# Inspector General

Independent Engineering Assessment of  
the Army's Transportation Plan for  
the BRAC Recommendation #133 Project  
Fort Belvoir - Mark Center, Virginia.

SUBJECT: Independent Engineering Assessment of the Army's Transportation Plan for BRAC Recommendation #133 Project Fort Belvoir - Mark Center, Virginia, (Report No. DODIG-2012-024)

Figure 4-2: Locations of Recommended Analysis Intersections

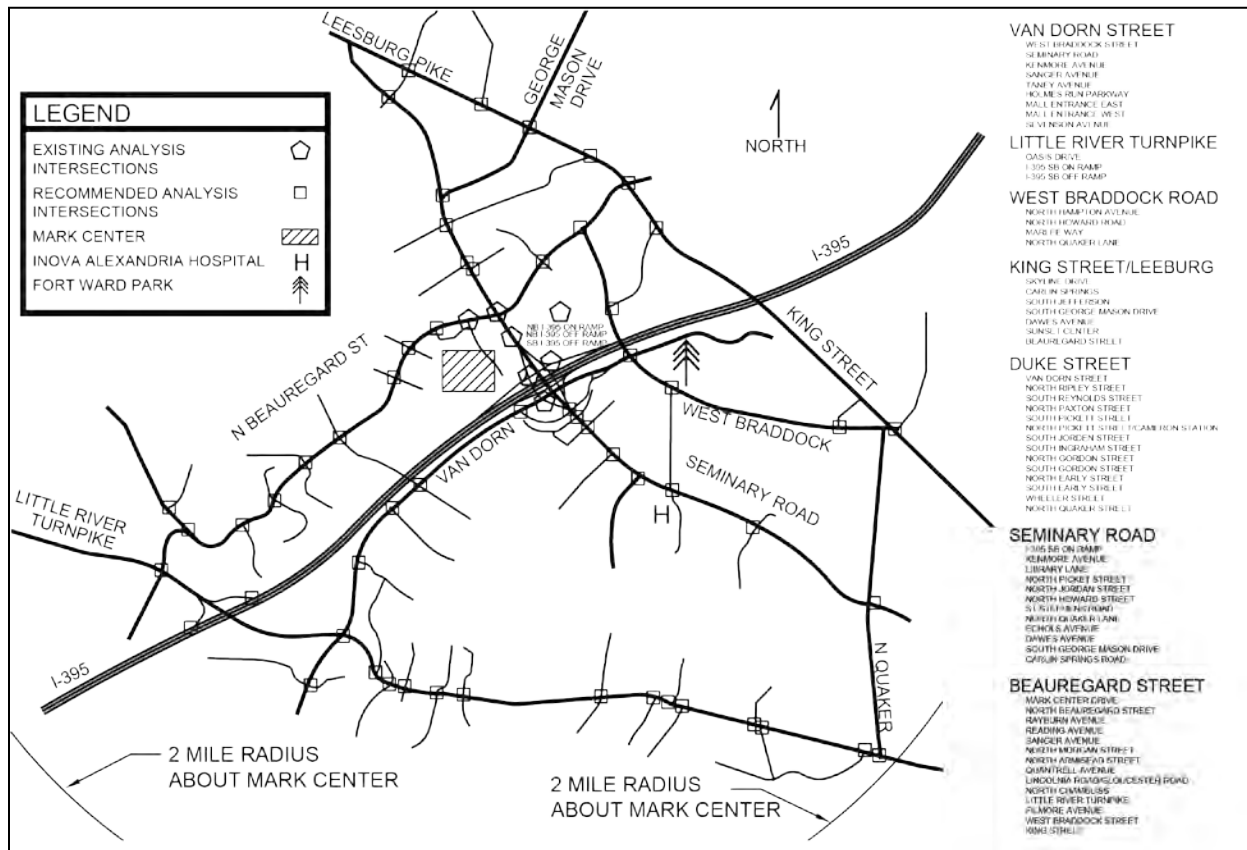
- Study Area – The Transportation Plan fails to evaluate the project impact at all signalized intersections within a two-mile radius and all un-signalized intersections within a one-mile radius.<sup>2B</sup> (ITE Recommended Practice, Table 2-3, pg. 10)

A map illustrating the location of these intersections and the two-mile radius is shown in Figure 4-2.

**Figure 4-3:** Independent Evaluation of the Roundabout

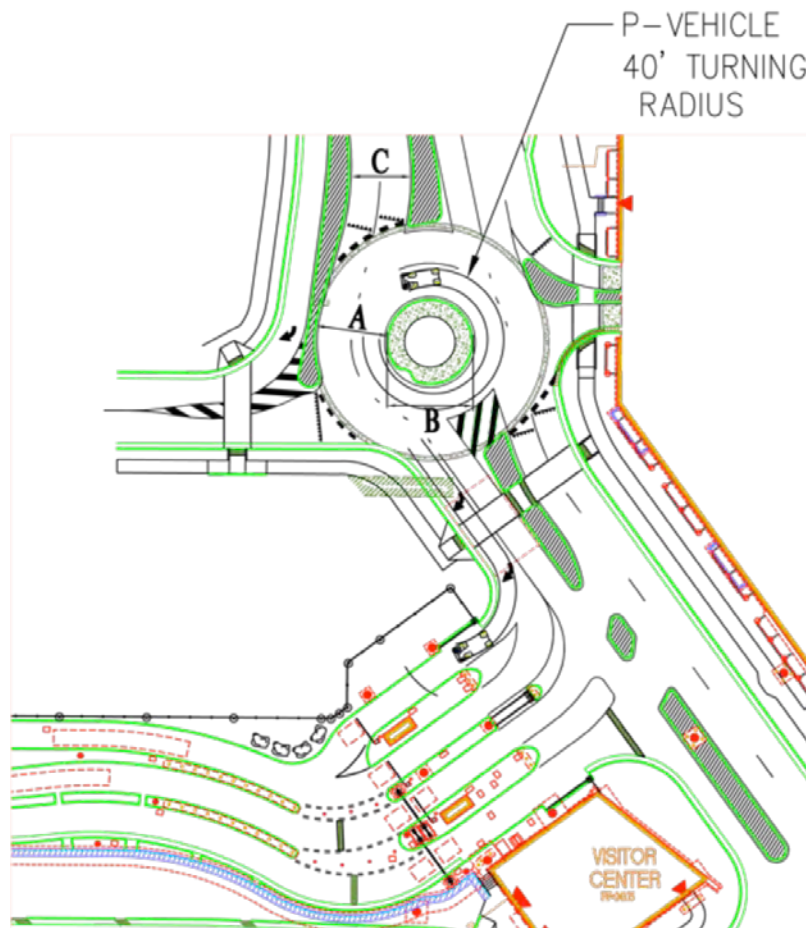
The SAMS assessment report also showed the deficiencies of the roundabout in the “Table 4-2 *Summary of Critical Roundabout Design Features*” and “Figure 4-3: *Independent Evaluation of the Roundabout*.” The SAMS assessment report further stated, “according to the WSDOT Design Manual, small changes in geometry can result in substantial changes in operational performance.”

As shown in Figure 4-3 below, the roundabout was not designed consistent with standard design practice for roundabouts. The dimensions of the roundabout are not sufficient to provide efficient traffic flow through the roundabout and into the North and South Parking Garages as well as IDA Drive. These design deficiencies will result in inefficient circulation and unnecessary congestion.

As shown in Figure 4-3, the proposed WHS Circle roundabout is deficient in all the pertinent design parameters. According to the WSDOT Design Manual<sup>7</sup>, small changes in geometry can result in substantial changes in operational performance.

It is recommended that the designer revisit the design of the roundabout and make necessary changes to improve operational performance which will maximize gate processing operations and overall traffic circulation on WHS Circle.

**Figure 4-6: Locations of Observed Pedestrian Service Deficiencies<sup>2</sup>**

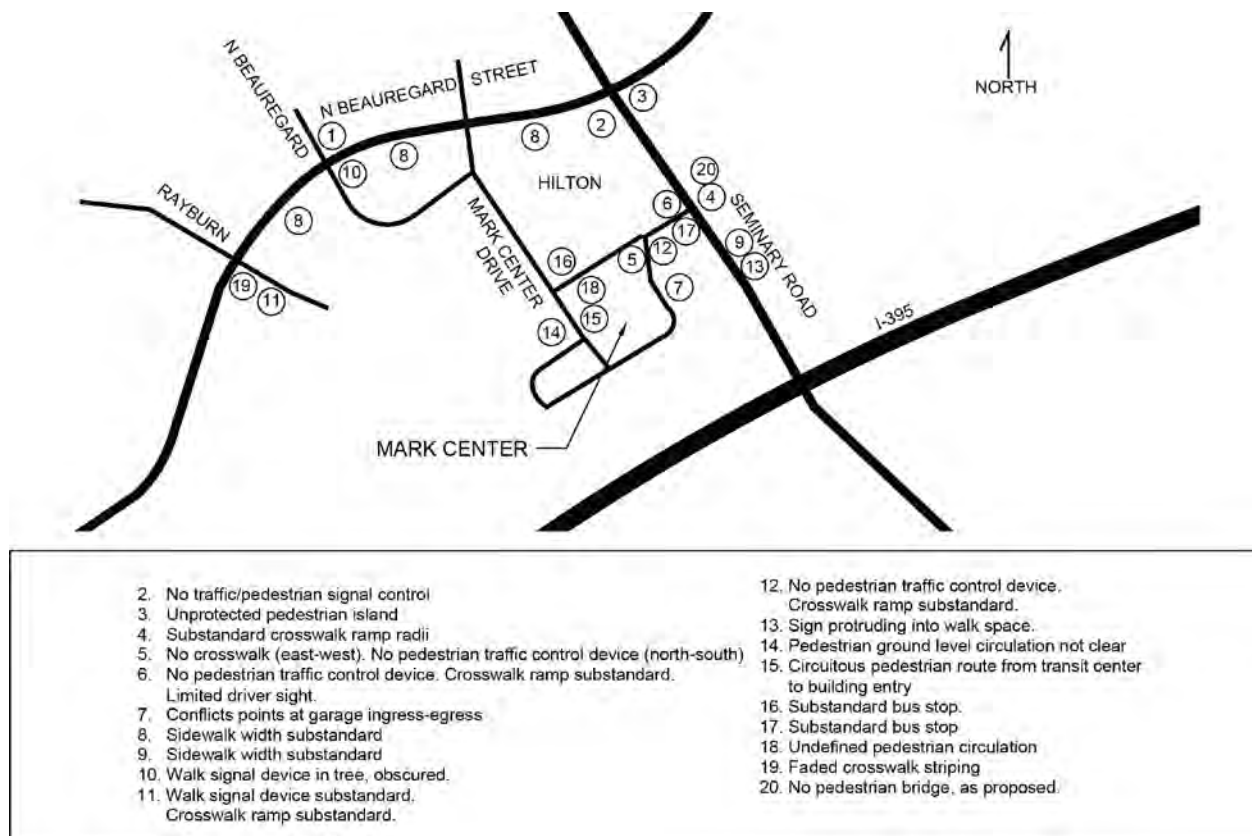
The deficient locations observed on the road network at and near the site are identified in Figure 4-6 below. Written descriptions of these locations is presented in the Appendix B: Table B-1: Pedestrian Service Field Observations At and Near the site of BRAC 133 Project Fort Belvoir – Mark Center, Virginia.

The findings that the pedestrian facilities in and around the BRAC 133 facility are unsafe and ADA-deficient are incorrect. Due to the weight that a finding of "ADA-deficient" carries, the Army requests that this inaccurate characterization be deleted from the final report. Each item in Figure 4-6, found on page 72 of the Independent Engineering Assessment and titled "Locations of Observed Pedestrian Service Deficiencies" is addressed here:

- 1- Item listed on figure 4-6 but not discussed in commentary
- 2- Please note the pedestrian control devices noted in the photograph (fig. 2)
- 3- Please note the 6" protective curbing in the photograph (fig. 3)
